Planning Commission Staff Report

Project Type:	Sign Package
Meeting Date:	March 25, 2019
From:	Mike Knight, Planner
Location:	14905 Clayton Rd.
Description:	<u>Mobil on the Run at Clayton and Baxter (Brite Worx) Sign Package:</u> A request for a Sign Package for a 1.72 acre tract of land zoned “PC” Planned Commercial District located on the western corner of the intersection of Clayton Rd. and Baxter Rd.

Figure 3: Signage Location

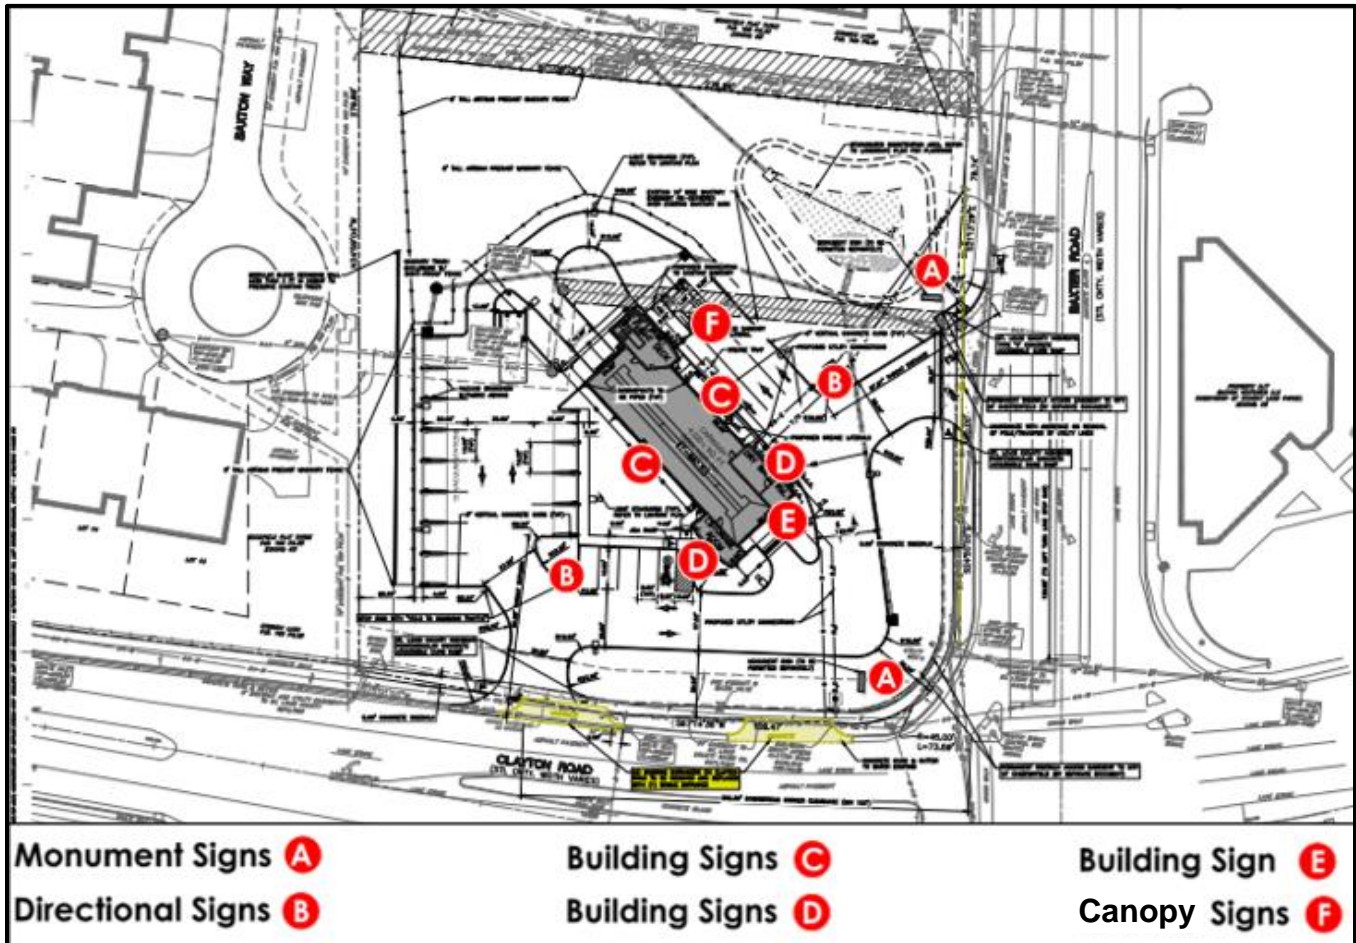
The proposed directional signs are single-sided with an outline area of 2.46 square feet. The height is 4 feet tall. The requested signs meet all of the sign requirement standards of the Unified Development Code. The location of both signs can be seen on Figure 3.

Figure 4: North Elevation Signage

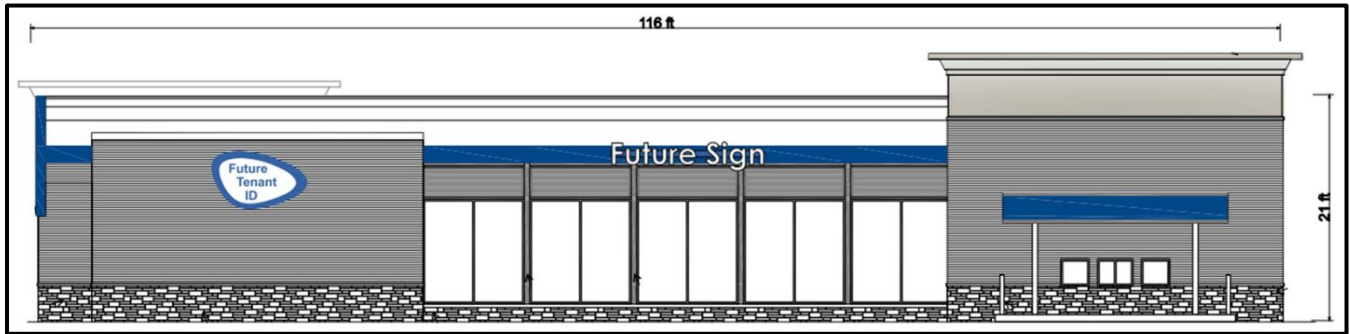
The applicant included signage on 3 separate building elevations, and canopy structure. Above in Figure 4 is the North Elevation. This is the elevation that will be primarily seen from Baxter Road. In accordance to Section 31-04-05F 3(b)1 of the UDC previously stated, the applicant is allowed one attached business sign on this wall up to 121 square feet. The applicant is proposing two attached wall signs. The “Future Tenant ID” sign seen above is 48.75 square feet and the “Future Sign” is 27 square feet totaling 75.75 square feet.

Figure 5: South Elevation Signage

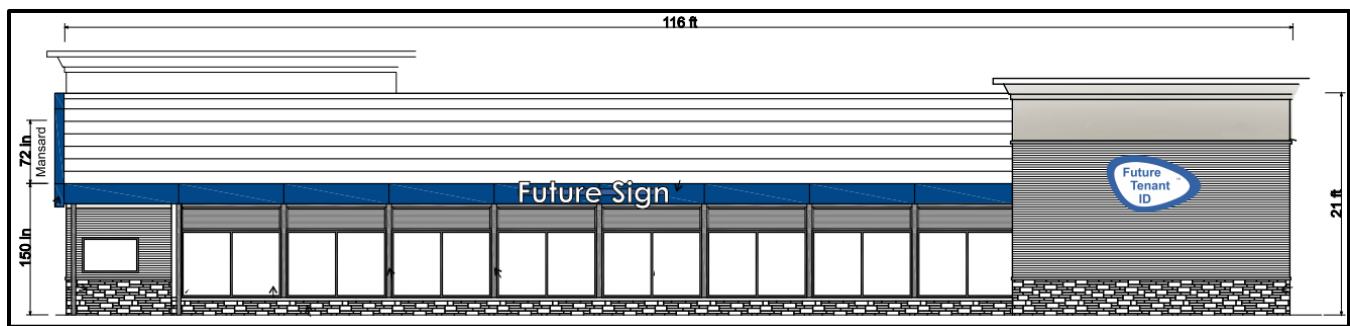
Figure 5 is the South Elevation. This is the elevation that will be primarily seen from viewers heading east on Clayton Road. In accordance to Section 31-04-05F 3(b)1 of the UDC stated above, the applicant is allowed one attached business sign on this wall up to 107 square feet due to the mansard roof. The applicant is proposing the same two signs as the North Elevation totaling 75.75 square feet.

Figure 6: East Elevation Signage

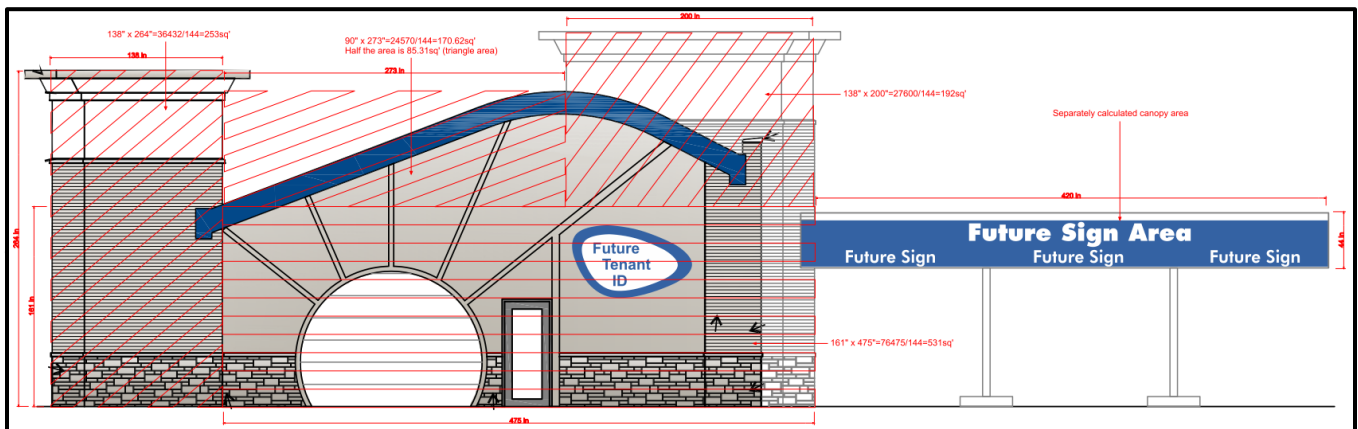
Figure 6 is the East Elevation. This is the elevation that will be primarily seen from viewers heading west on Clayton Road. In accordance to Section 31-04-05F 3(b)1 of the UDC stated above, the applicant is allowed one attached business sign on this wall up to 52 square feet. The applicant is proposing the same "Future Tenant ID" sign as the previous elevations totaling 38.7 square feet.

There is also a canopy attached to this elevation. Section 31-04-05F 8(g) of the Unified Development Code states that a service station with a canopy may have no more than one (1) sign which may include the name and logo of the business and one (1) sign which may include the words "self-service" and "full service" attached on each of any two (2) sides of the vertical face of the canopy, excluding canopy supports. The outline area of each sign shall not exceed ten (10) square feet in outline area. Each sign shall be a flat sign permanently affixed to the vertical face of the canopy and shall not project above or below the vertical face of the canopy more than one (1) foot. No projection shall be permitted from any other side of the vertical face of the canopy. Such signs shall only be illuminated by internal and non-intermittent light sources. For service stations located on corner lots, such signs may be located on each of any three (3) sides of the vertical face of the canopy, excluding canopy supports.

In accordance to Section 31-04-05F 8(g) stated above, the canopy may have 2 signs on 3 different sides, not to exceed 10 square feet in outline area for each sign. The applicant is proposing 4 signs solely on the East Elevation that total 47.3 square feet.
